AGENDA
CITY OF TULSA BOARD OF ADJUSTMENT
Regularly Scheduled Meeting
Tulsa City Council Chambers
175 East 2nd Street, 2nd Level, One Technology Center
Tuesday, February 27, 2018, 1:00 P.M.

Meeting No. 1200

1 SITE PLAN
SCALE: 1"=20'-0"

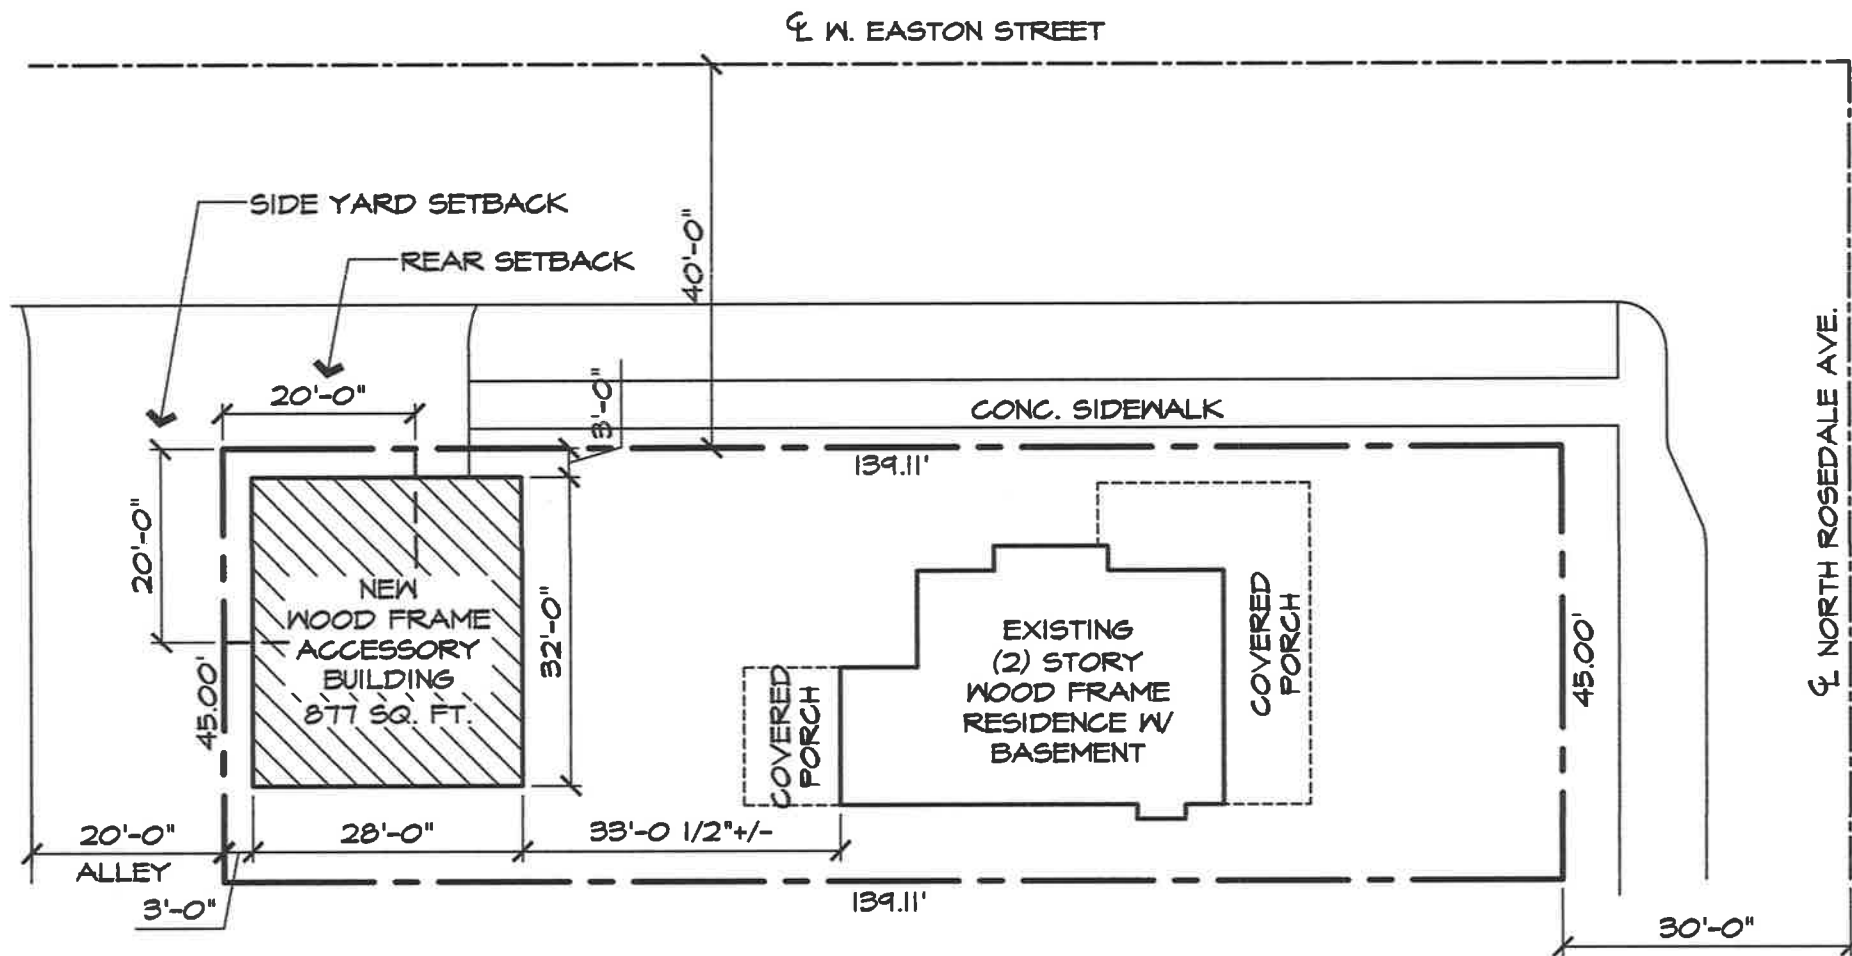
Review Comments: This lot is zoned RS-3. The rear setback is defined as the minimum distance set out by the zoning code of open unoccupied space between the rear lot line and the required rear setback (in your case, 20 feet from the rear property line). A maximum 30% area can be covered by the accessory building; (45' X 20' X 30%) allows 270 sq ft of coverage. You are proposing 609 sq ft of coverage in the rear setback. Revise your plans to show compliance or apply to BOA for a variance to allow more than 30% coverage in the rear setback.

Review Comments: Revise plans to indicate that the detached accessory building will set back at least 3 feet from all interior lot lines or apply to the BOA for a variance to allow an accessory structure to be located less than 3 feet from all interior lot lines.

Review Comments: Revise plans to indicate a 20' street setback from Easton Street. If you are unable to meet the street setback requirements mentioned above, then you will need to apply to the City of Tulsa Board of Adjustment (BOA) for a Variance to reduce the required street setback.

SITE PLAN
SCALE: 3/32" = 1'-0"

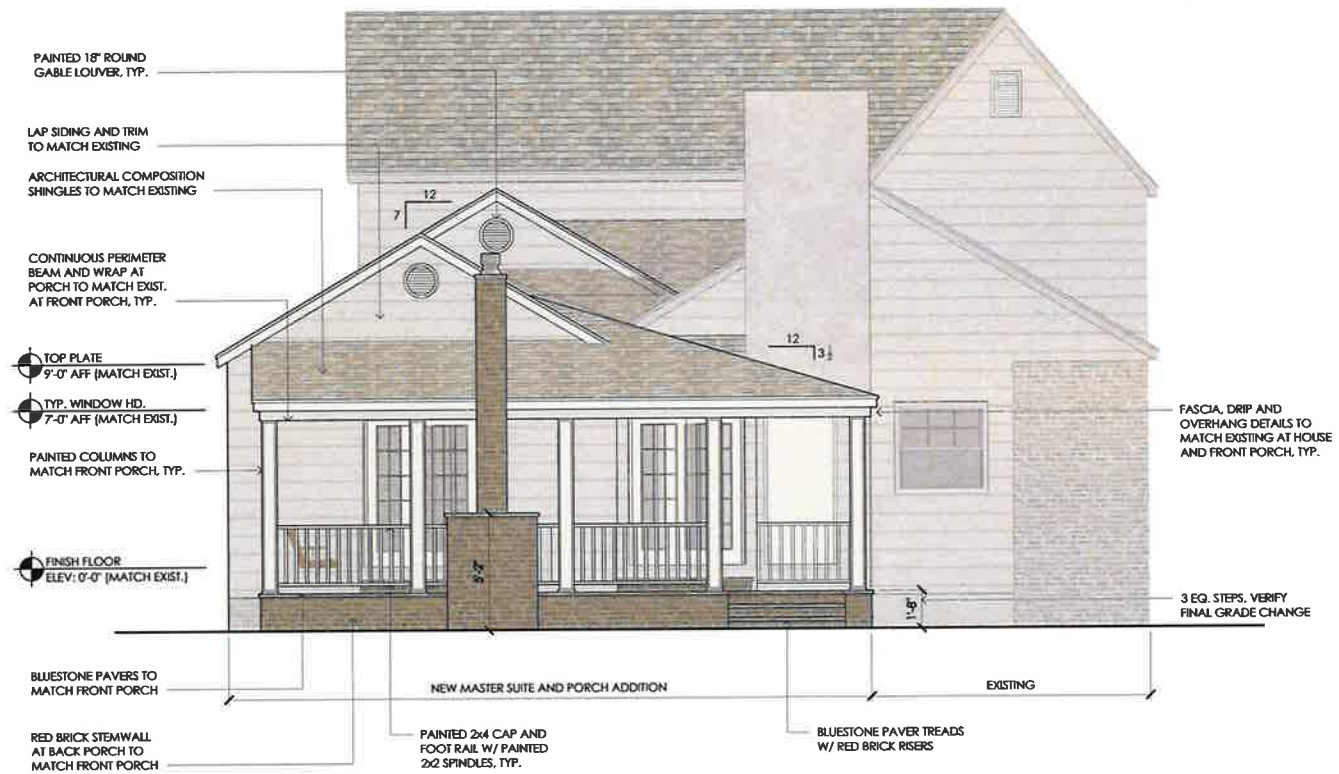
Review Comments: Minimum required open space for Detached House in a RS-3 zoned lot is 4000 square feet. Calculations indicate per the submitted site plan and county assessor's property search that you will have 3410 sq ft of open space on this lot. If you are unable to reduce the size of your addition to meet the 4000 sq ft requirement you will need to apply to BOA for a variance to allow less than 4,000 sq ft of open space on this lot.

1 SITE PLAN
SCALE: 1/8" = 1'-0"

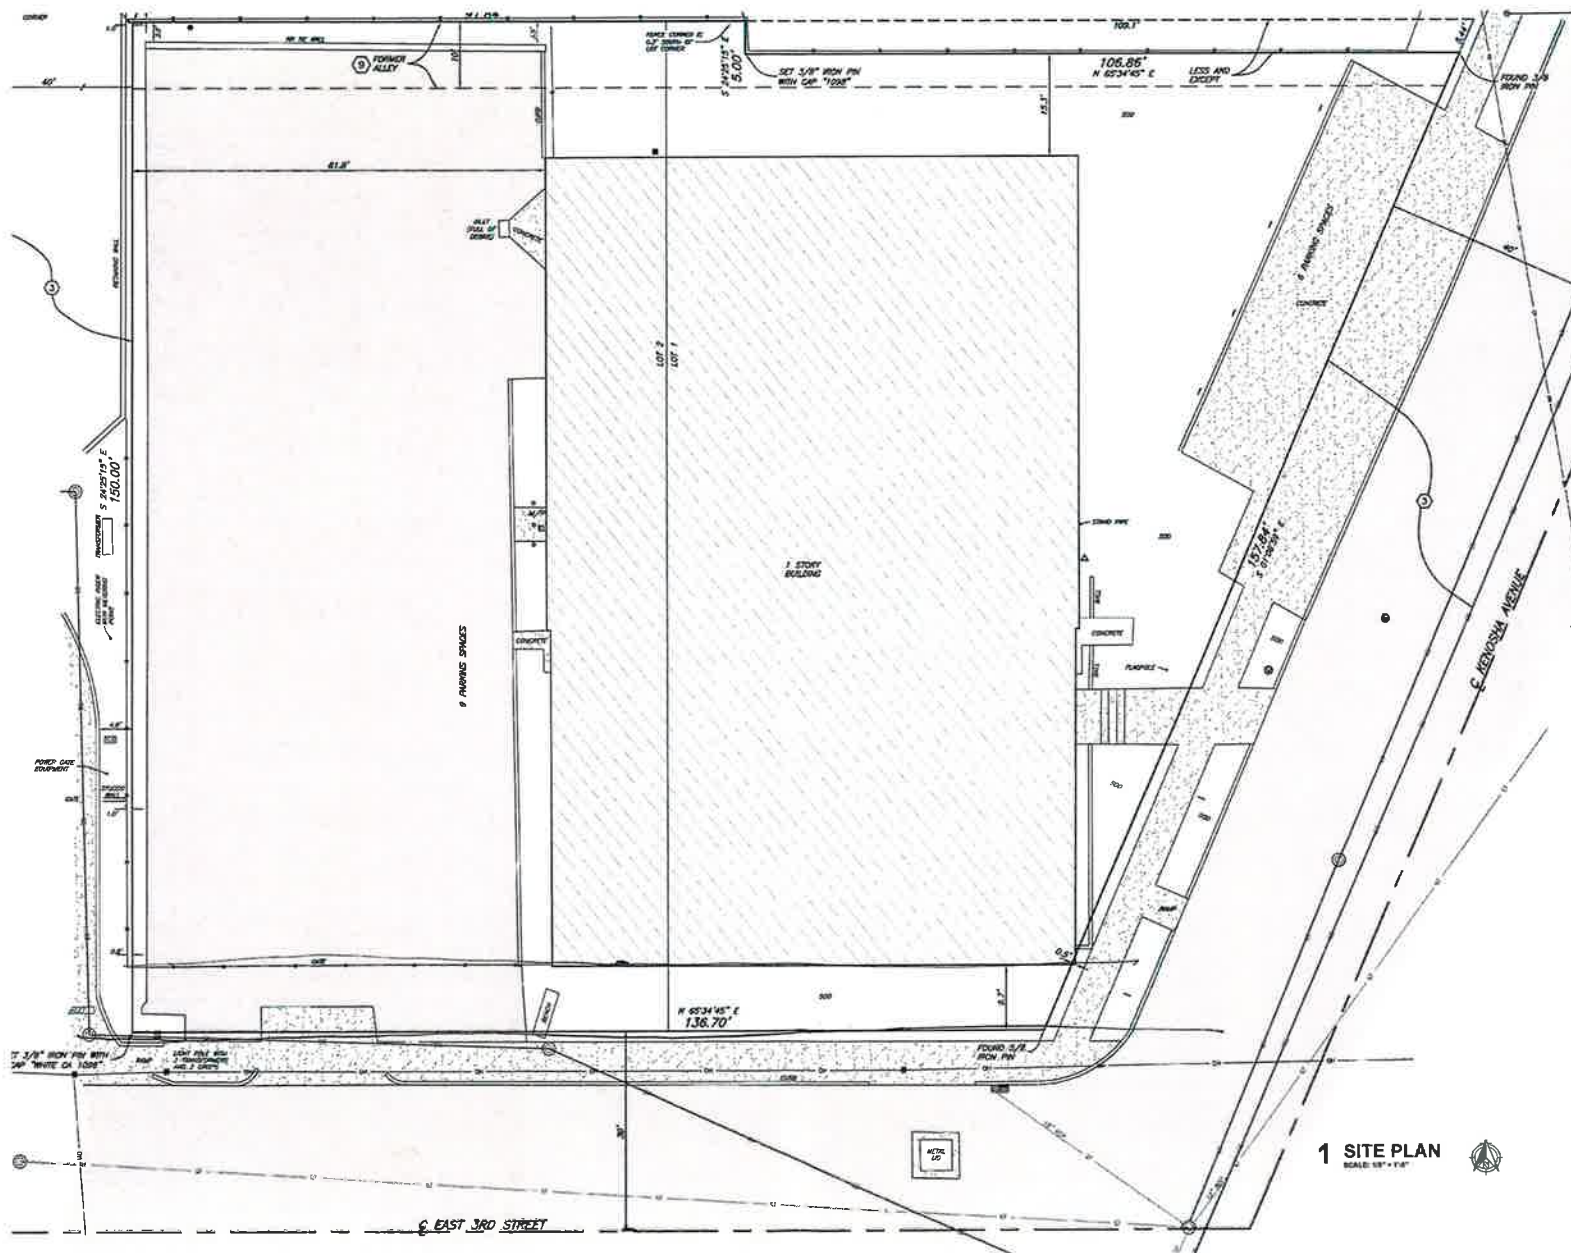
Review comment: The West parking area is required to have an isle width of 22 feet for 90 degree two way parking. Revise the plans to comply with 55.090.D or you may pursue a variance to permit the parking area design isle maneuvering width be reduced from 22 feet to 19 feet. In addition motorized vehicles are not permitted to back out from the parking area to the East onto a major street (Commercial Industrial Street). Revise the plans to comply with 55.090.D or you may pursue a variance from the BOA to permit vehicles to exit the lot in a rearward motion onto S. Kenosha Avenue.

Review comment: The proposed retaining wall, concrete stairs and outdoor patio with trellis structure along E. 3rd Street and the outdoor patio and a portion of the parking area along S. Kenosha Avenue appear to be

located within the City of Tulsa planned Right of Way. Submit a site plan that provides the building/Structures and all parking spaces located out of the planned ROW or you may pursue a variance from the BOA to permit a retaining wall, concrete stairs and outdoor patio with trellis structure along E. 3rd Street and the outdoor patio and a portion of the parking area along S. Kenosha Avenue to be located within the City of Tulsa planned Right of Way.
